Access Compliance Report Public Rights-of-Way (RR Crossings)

Intersection ID: 7131	Main Street: N_TRYON_ST	Location: N/A
ADA ID: A9A12FE7A819	Overall Compliance: No	Severity Score: 0.0
Codes/Mitigation Info/Possible Solution		Field Measurements/Component Compliance

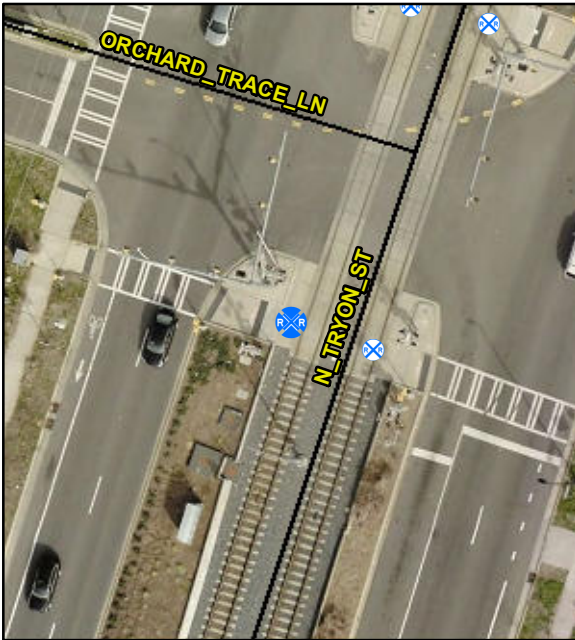
R302.7.4, R305.2.5

Compliance	Description	Data
Yes	DWS Provided?	Yes
Yes	DWS Contrast?	Yes
Yes	DWS Width (in)	Yes
Yes	DWS Length (in)	24.0
No	DWS Offset (in)	41.5
Yes	Pedestrian Gate?	Yes
N/A	DWS Outside Gate?	Yes
N/A	Rail Type?	LightRail
No	Flangeway Gap (in)	2.5
Yes	Sidewalk Width (in)	167.5

**Remove & Replace Detectable
Warning System. Remove & Replace
Walking Surface Adjacent to Rail.**
